ARCHITECTURAL PLANS

ITEM 9.1.1
 APPENDIX B

SCHEDULE OF SUBMISSIONS

NORTH WALL BRICKWORK DETAIL

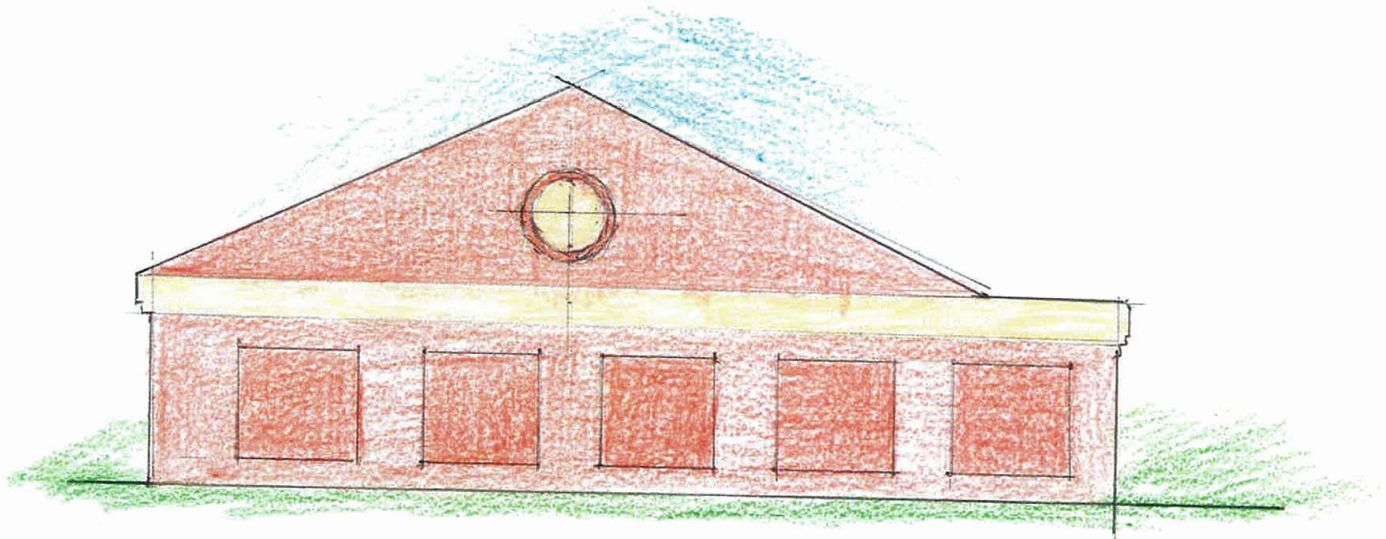
No.	Name Address	Description of Affected Property	Summary of Submission	Council's Recommendation
1.	Martin Petch (27/4/13)	3 Meares Street, York	<p>I wish to lodge an objection to the proposed building of 7 (seven) single storey units on the above block.</p> <ol style="list-style-type: none"> 1. 7 units in a small block (1/4 acre of so) is not necessary in York, this is high density accommodation at its worst. Such housing may be acceptable in Perth suburbs, but not in a small town like York. Such density is a catalyst for arguments between neighbours and the lowering of the tone in the neighbourhood, let along the value of the properties in the area. I also have reservations on the end user as stated in the proposal, probably short term rentals more like, with no interest in local activities. 2. According to the plans I will have a 4 to 5 metre high brick wall on my boundary fence, I thought there had to be a minimum gap between lots, with such a wall it will block the views from two bedrooms, bathroom, and kitchen, and subsequently loss of light into those rooms, this will also compromise light on to the garden thus rendering any veg garden useless should this happen next to a <u>heritage listed building</u>. 3. Will the sewerage be up to it as the pipe in that location is at its lowest point of flow, I know this because I asked the people who put it in why it didn't come to my block, and if there are 7 units using it possible "back-ups" will start causing health problems, even if a pump is installed a 	<p>The issues raised in the submission have been noted and considered throughout the development assessment process. The following comments are provided to each of the concerns raised:</p> <ol style="list-style-type: none"> 1. This area has been identified in the Local Planning Strategy for higher density residential development and has been R-coded R40 accordingly. As indicated in the report, over half of WA's households consist of one or two persons, and therefore, housing must be provided to accommodate their needs. This development will provide affordable housing close to the town centre. There is no evidence that properties used for short-term rentals have negative social outcomes or devalue properties. It is likely that these units, from discussions with local real estate agents, will be owner-occupied by older persons looking to downsize from their current larger single dwellings. 2. Whilst there may be some loss of light to the rooms, this should not be significant, particularly as the aspect of the sun is based in the North in Summer and even further North in Winter and complies with the provisions of the R-Codes. Discussions with the applicant have resulted in an addendum being received that provides an example of detailing on the brickwork for the north facing wall. The intent of these details including;
